△ DRAINAGE PLAN UPDATE

JOB NO.
910801
DATE
10/91

CONCEPTUAL GRADING & DRAINAGE PLAN UPDATE
LOVELACE NEURO-BEHAVIORAL HOSPITAL

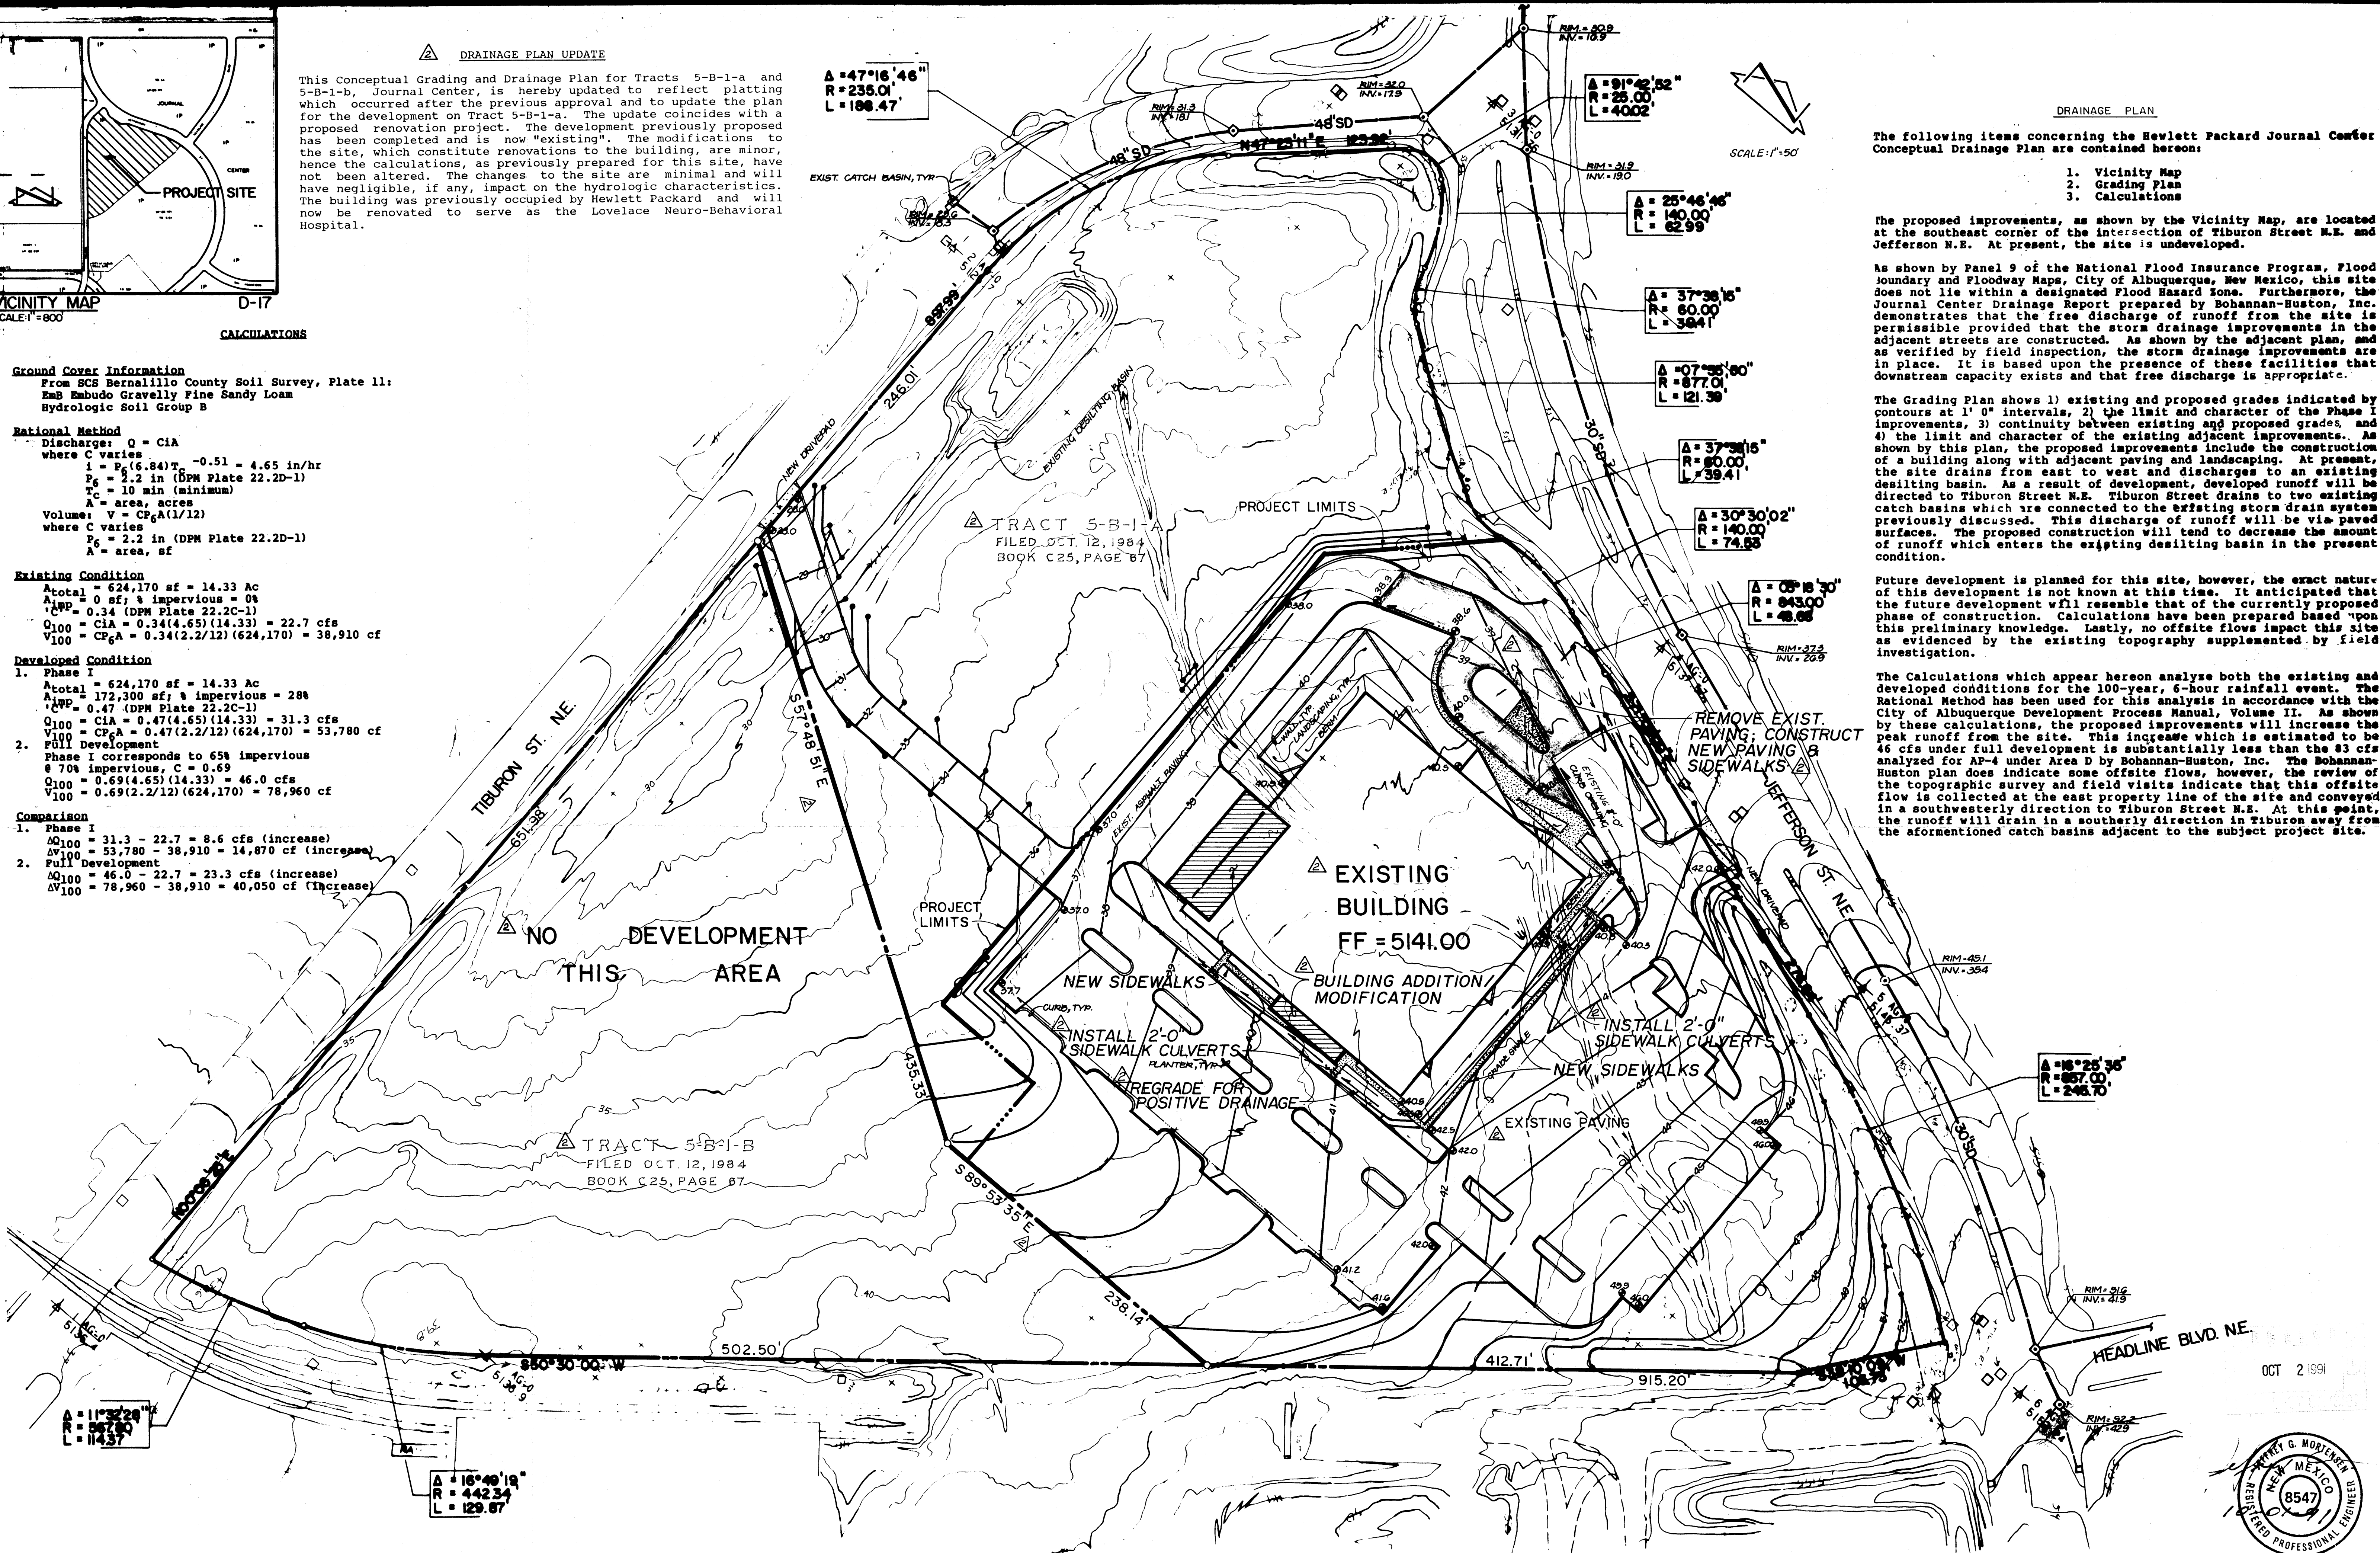
This Conceptual Grading and Drainage Plan for Tracts 5-B-1-a and 5-B-1-b, Journal Center, is hereby updated to reflect platting which occurred after the previous approval and to update the plan for the development on Tract 5-B-1-a. The update coincides with a proposed renovation project. The development previously proposed has been completed and is now "existing". The modifications to the site, which constitute renovations to the building, are minor, hence the calculations, as previously prepared for this site, have not been altered. The changes to the site are minimal and will have negligible, if any, impact on the hydrologic characteristics. The building was previously occupied by Hewlett Packard and will now be renovated to serve as the Lovelace Neuro-Behavioral Hospital.

NO.	DATE	BY	REVISIONS
1	7/25/89	J.M.	LOWER P.P. & ELIMINATE DOCK AREA
2	9/27/91	J.M.	UPDATE FOR HOSPITAL RENOVATION & REPLAT
